Docket No. 50-269

Change No. 3
License No. DPR-38

Technical Specifications 1.6, 1.8, 2.1, 2.3, 3.1.3, 3.5.2, 3.11, 4.1 and 4.7 are revised as the enclosure to this letter. This change will be known as Change No. 3 to the Technical Specifications, License DPR-38 and is effective on date of issuance.

Enclosure:
Change No. 3 to DPR-38

Figure 2.1 - 2

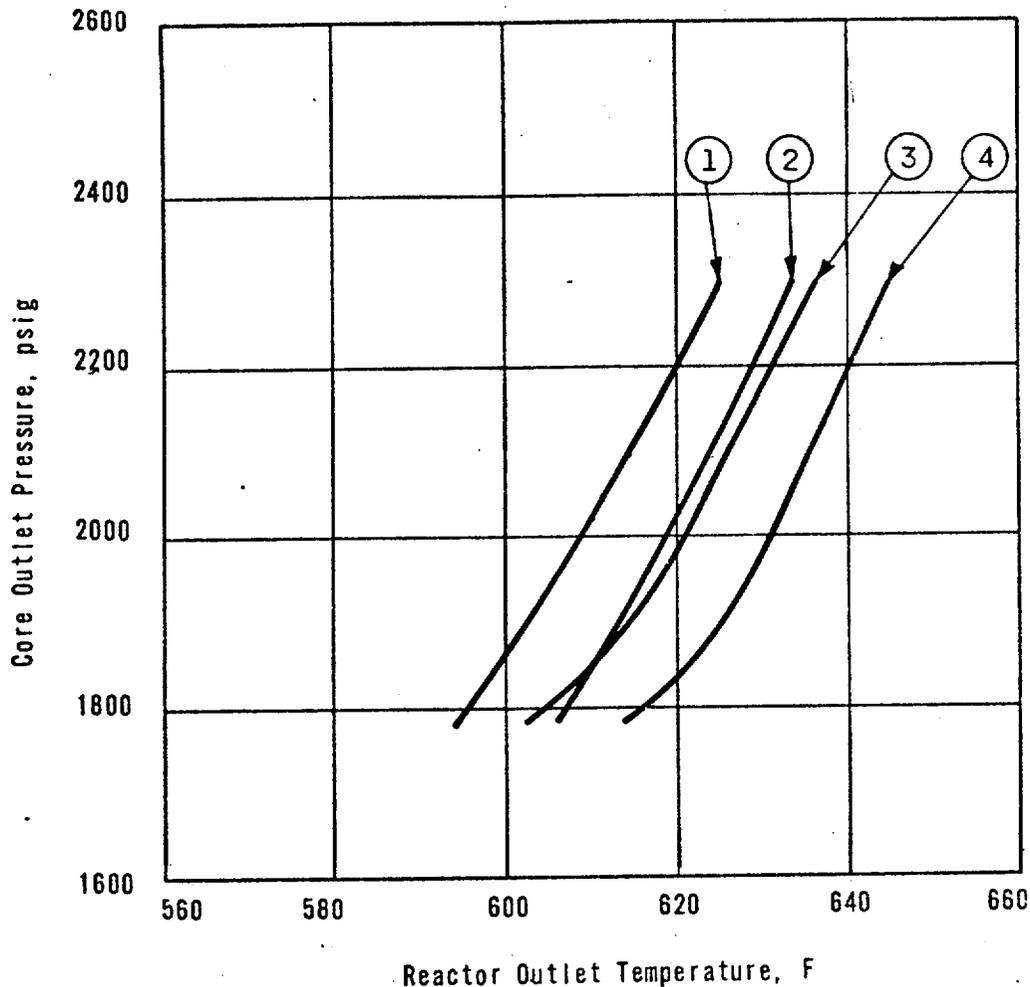
The curves of Figure 2.1-2 are based on the more restrictive of two thermal limits and include the effects of potential fuel densification:

The specified flow rates for curves 1, 2, 3, and 4 of Figure 2.1-2 correspond to the expected minimum flow rates with four pumps, three pumps, one pump in each loop and two pumps in one loop, respectively.

Figure 2.3 - 1

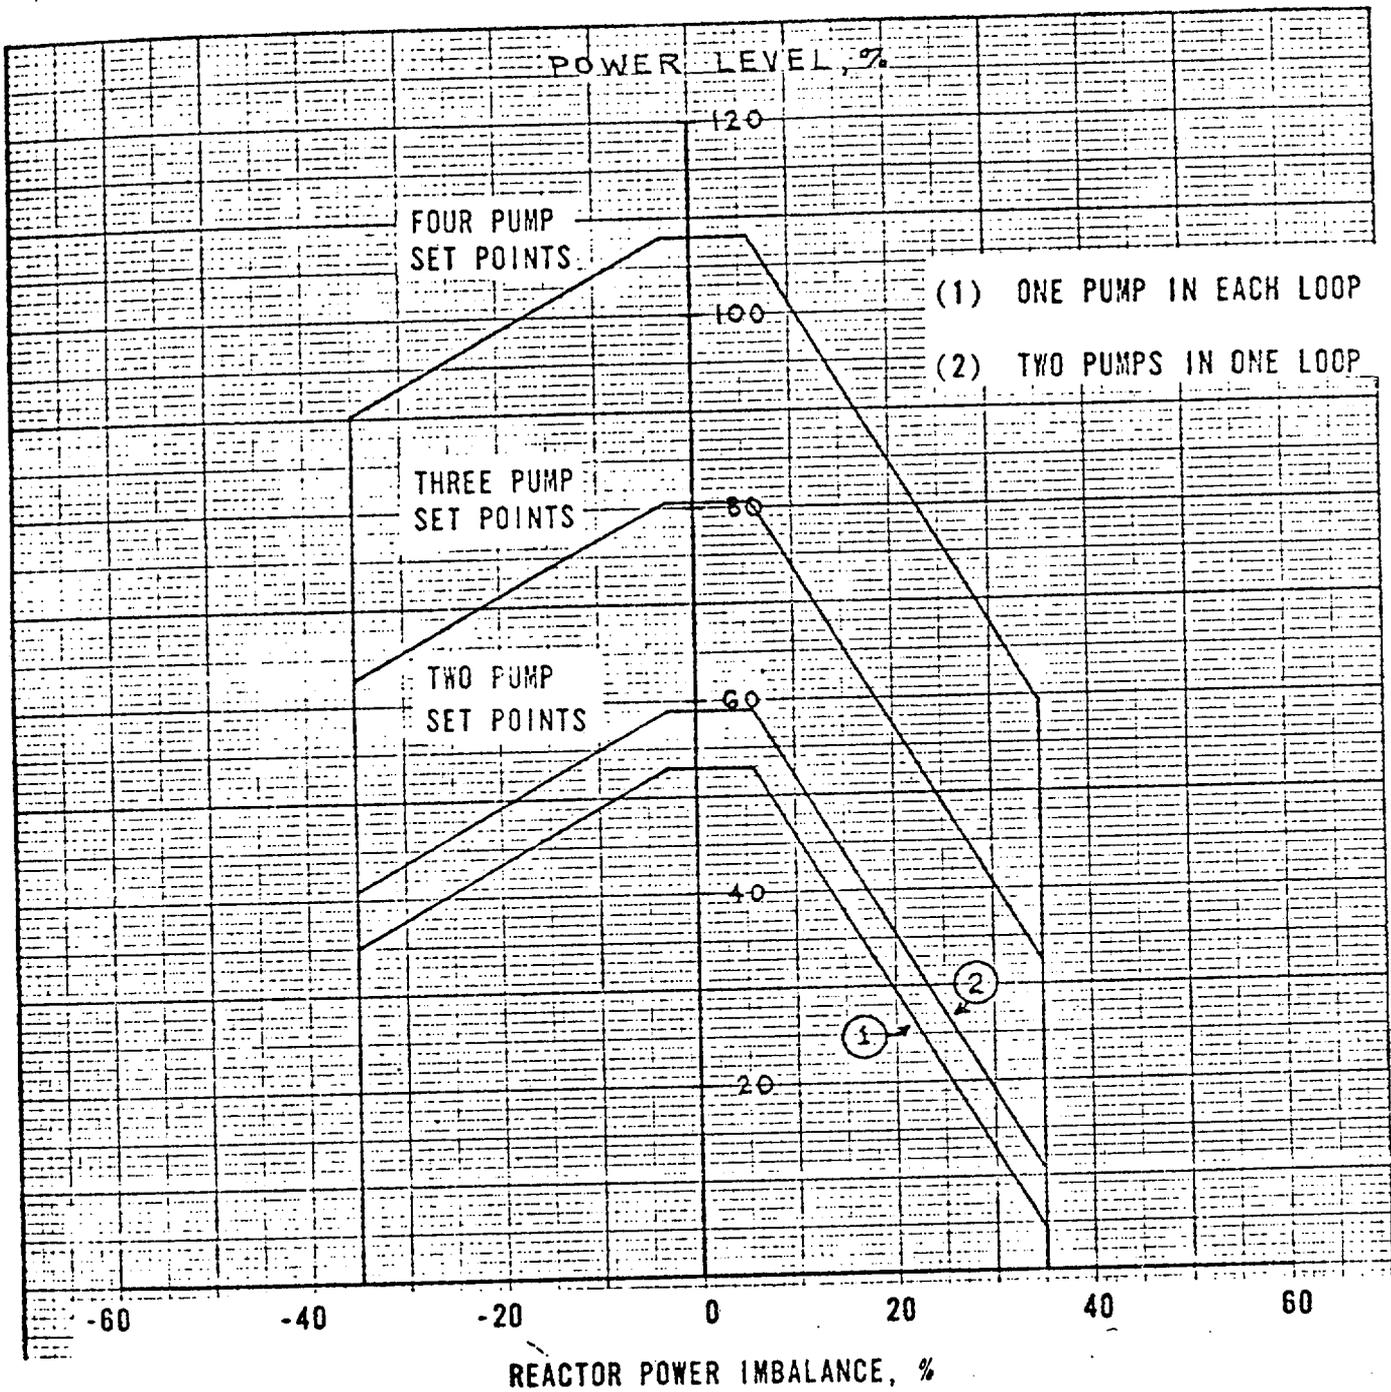
During a startup accident from low power or a slow rod withdrawal from high power, the system high pressure set point is reached before the nuclear overpower trip set point. The trip setting limit shown in Figure 2.3-1 for high reactor coolant system pressure (2355 psig) has been established to maintain the system pressure below the safety limit (2750 psig) for any design transient.⁽¹⁾

The low pressure (1800 psig) and variable low pressure ($16.25T_{out} - 7769$) trip setpoint shown in Figure 2.3-1 have been established to maintain the DNB ratio greater than or equal to 1.3 for those design accidents that result in a pressure reduction.^(2,3)

The high reactor coolant outlet temperature trip setting limit (619 F) shown in Figure 2.3-1 has been established to prevent excessive core coolant temperatures in the operating range. Due to calibration and instrumentation errors, the safety analysis used a trip set point of 620 F.

Figure 3.5.2-2

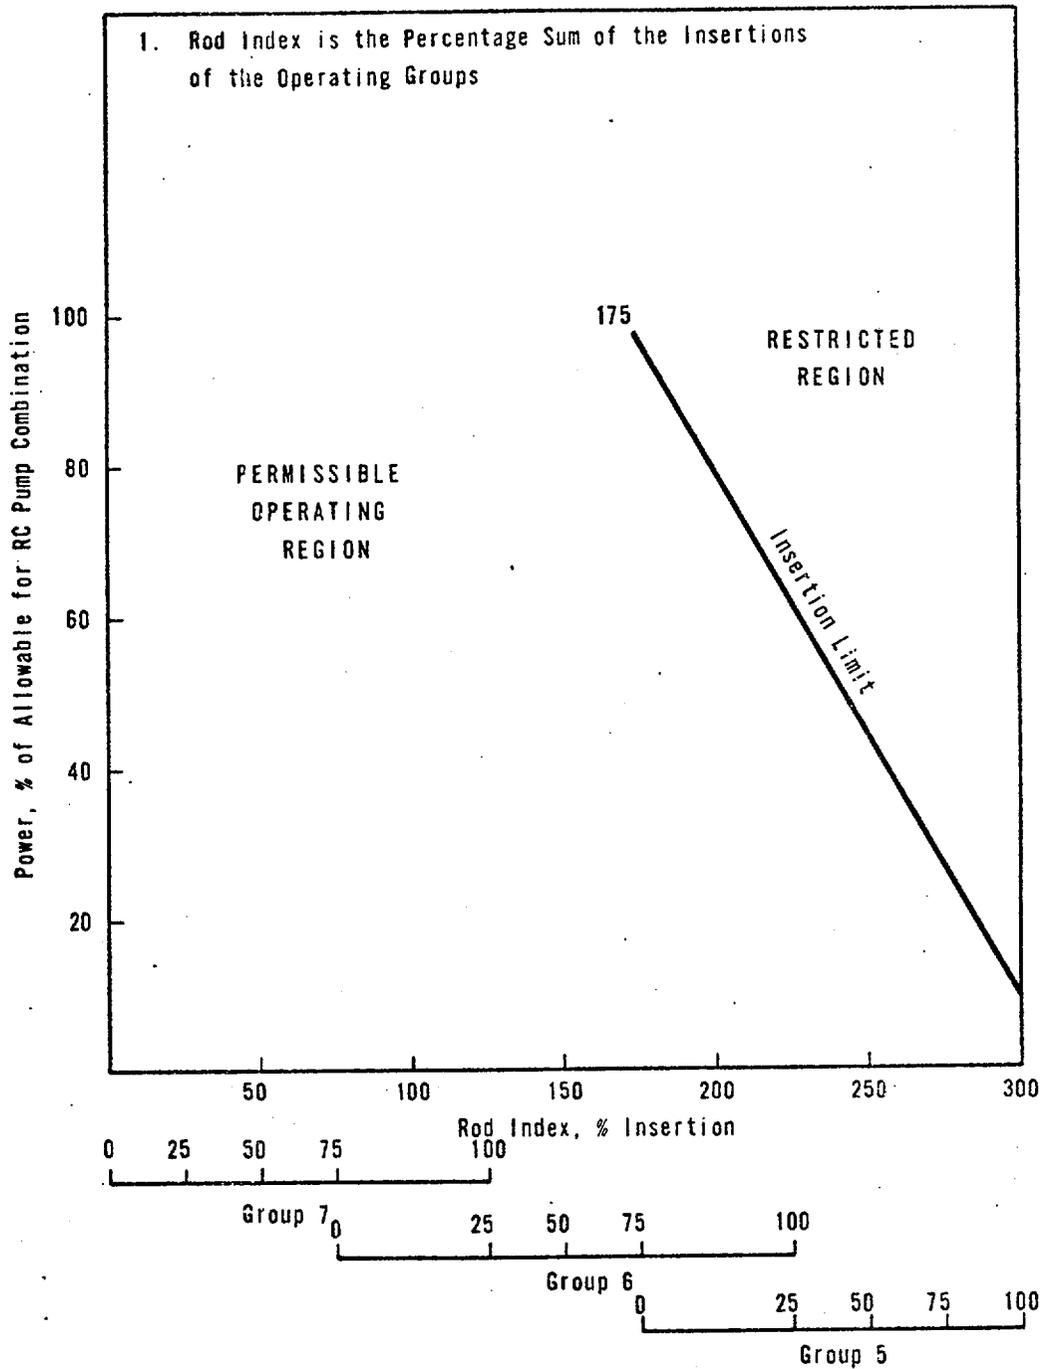
- b. Operating rod group overlap shall not exceed 30% between two sequential groups, except for physics tests.
- c. Except for physics tests or exercising control rods, the control rod insertion limits are specified on Figure 3.5.2-1 for four pump operation and on Figure 3.5.2-2 for three or two pump operation.
- d. If the absolute value of core imbalance is in excess of 5%, except for physics tests, the minimum imbalance achievable shall be determined on a minimum frequency of once per hour until corrected. The axial power shaping rod group shall be used to maintain the core imbalance to within 5% imbalance of the minimum achievable imbalance. The axial power shaping rod group is not restricted from being fully withdrawn.
- 3.5.2.6 The control rod drive patch panels shall be locked at all times with limited access to be authorized by the superintendent.
